Inspection Report for North Sturbridge Road Solar Facility

NPDES ID No.: MAR10031G

Inspection Date: 8/23/2022

**FIGURE 1:
SWPPP
INSPECTION
SKETCH
8/23/2022**

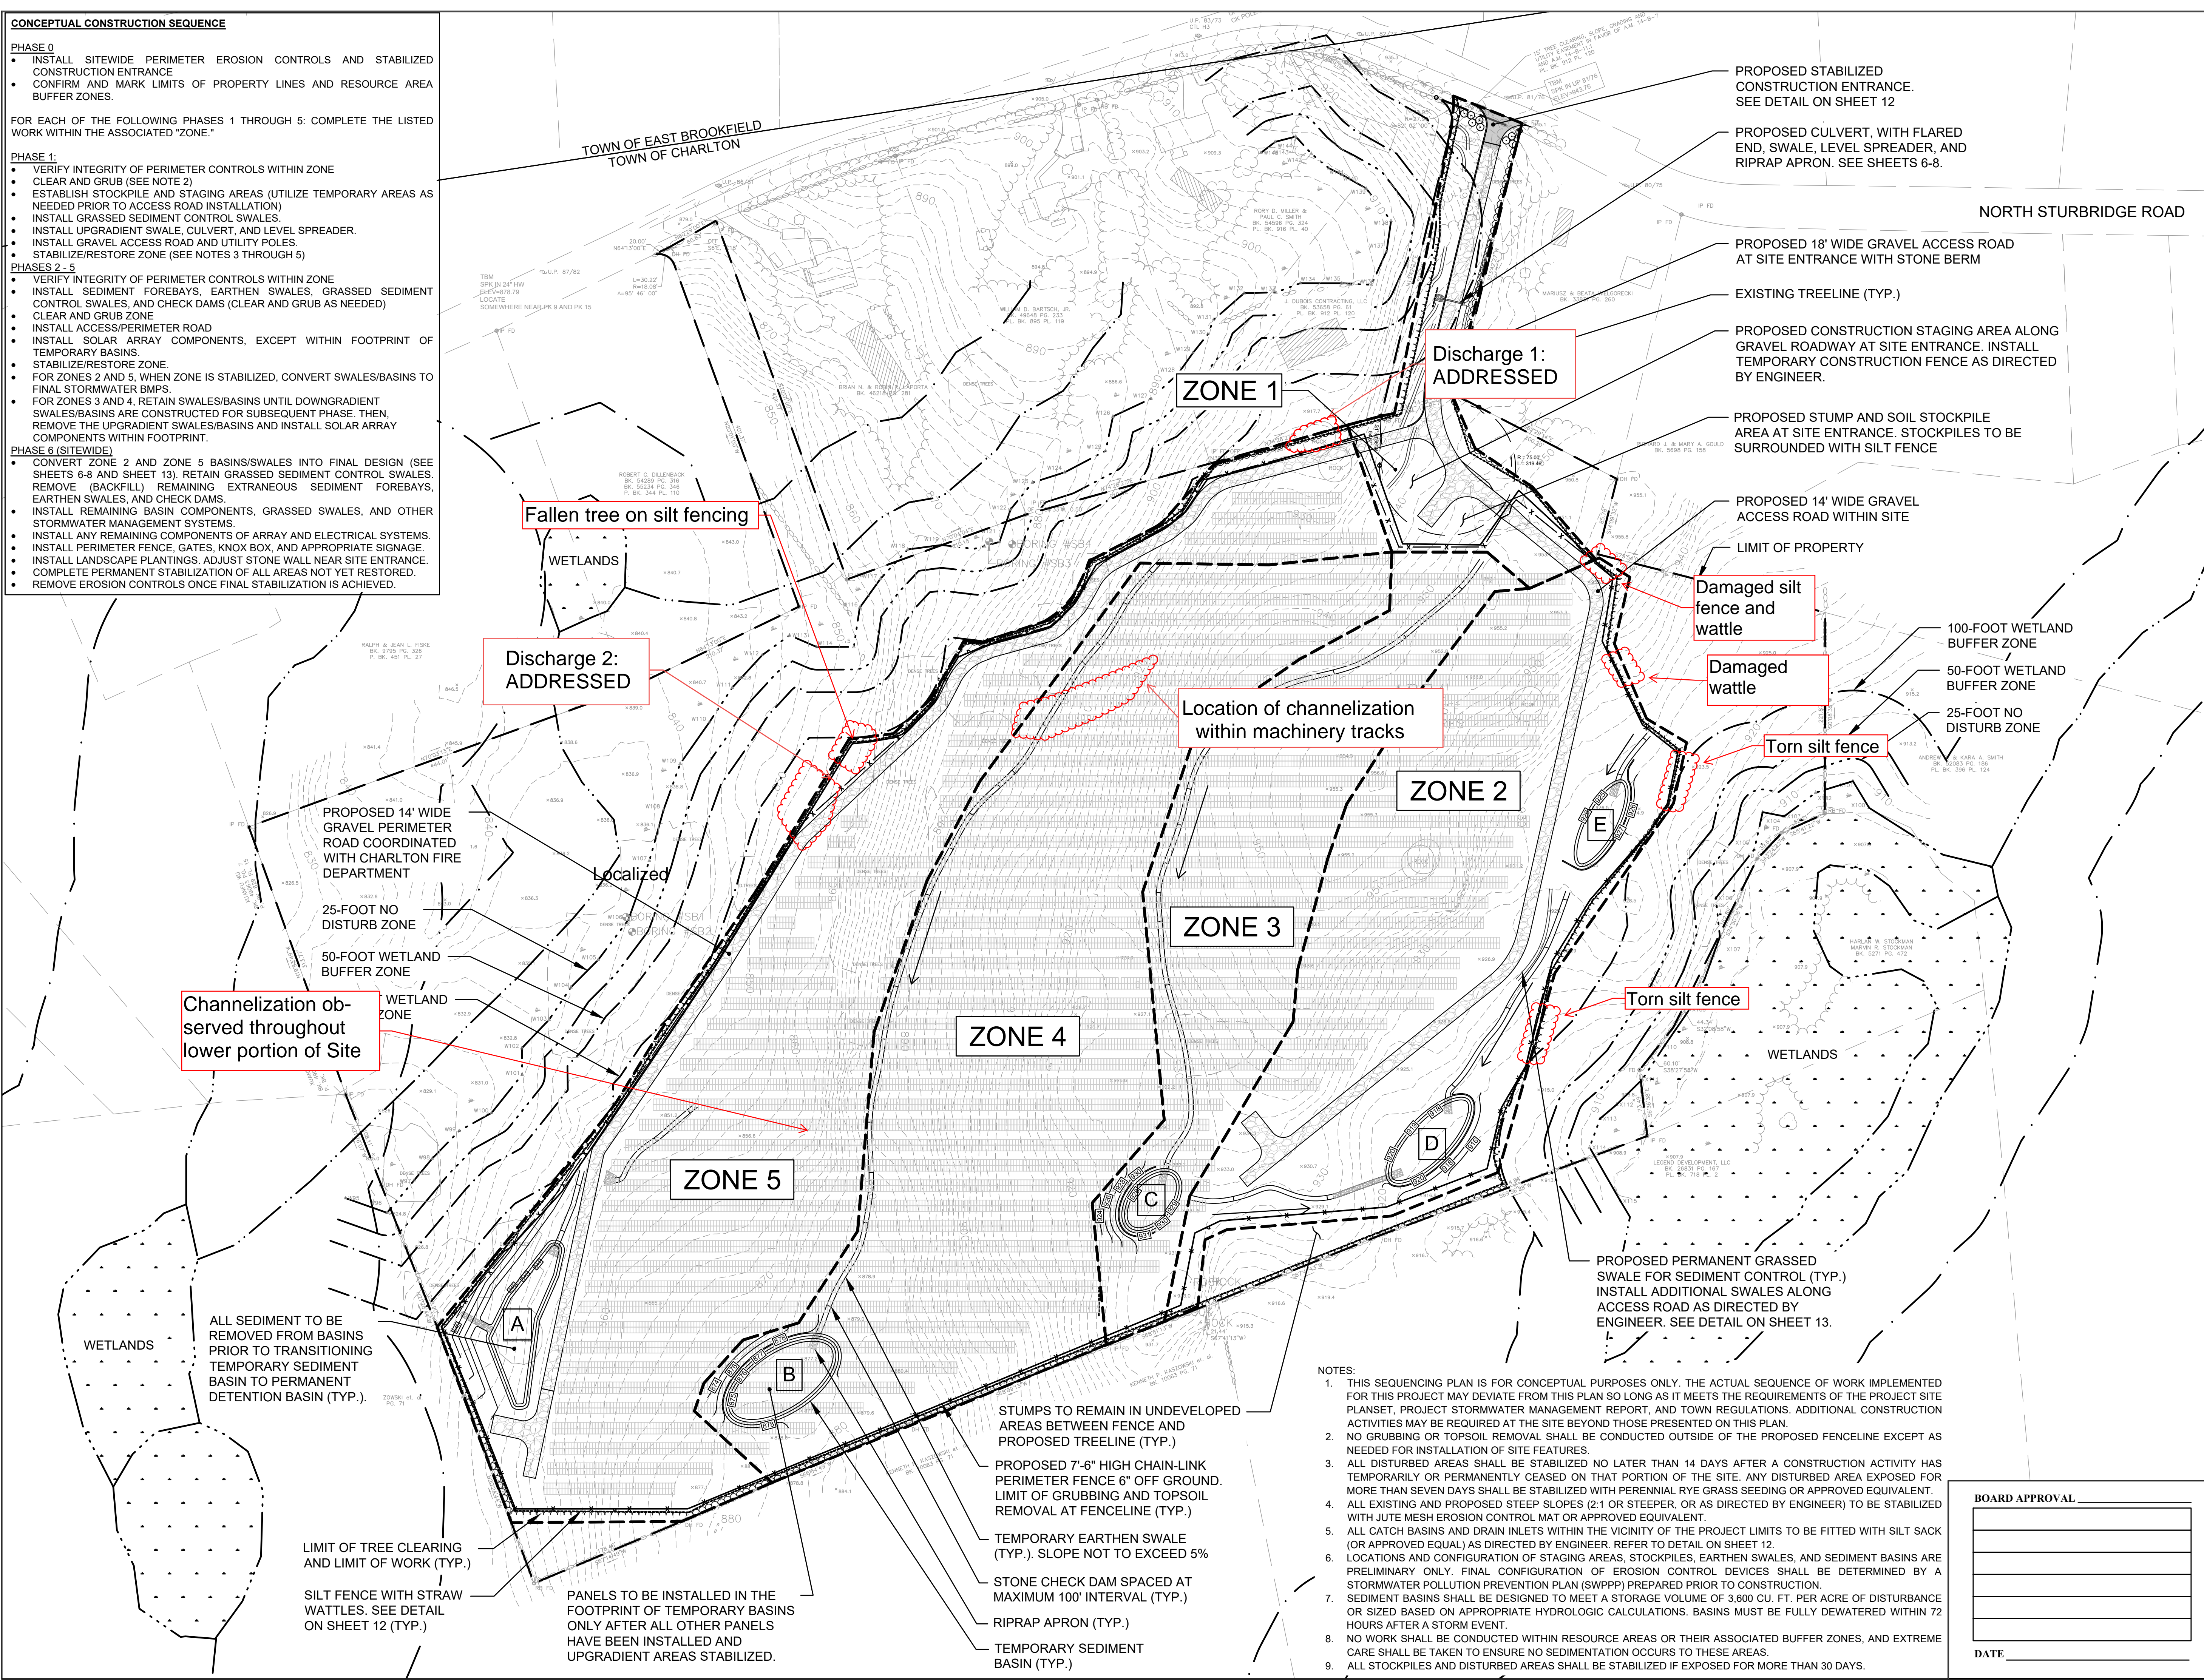
Type/Location of E&S Control	Maintenance Needed?*	Corrective Action Required?*	Date on Which Maintenance or Corrective Action First Identified?	Notes
1. Silt Fence and Straw Wattles	Yes	No	3/15/2022	On 8/23/2022 BETA observed fallen tree damage to the silt fence on the western perimeter of the Site, damage was first observed on 6/20/2022 On 8/23/2022 BETA observed damage to the wattles in the north-east and eastern corners of the Site, damage was first observed on 3/15/2022. BETA also observed the silt fence to be partly torn in the southeastern corner of the Site, damage was first observed on 3/27/2022. General maintenance is needed for the entire silt fence. No evidence of discharge was observed.

2. Informal access road along northern portion of the Site	Straw mulch or hydroseed	<input type="checkbox"/> Yes <input checked="" type="checkbox"/> No	Erosion channels are beginning to form within upgradient portions of the informal access road (Figure 1). The contractor indicated that stabilization by smoothing out soils and seeding or spreading mulch would occur on 7/30/2021. Stabilization of this area has not been initiated. After inspection of the area on 8/24/2021, it was determined that

Damaged silt fence and wattle

Damaged wattle

Torn silt fence

Torn silt fence

Fallen tree on silt fencing

Channelization observed throughout lower portion of Site
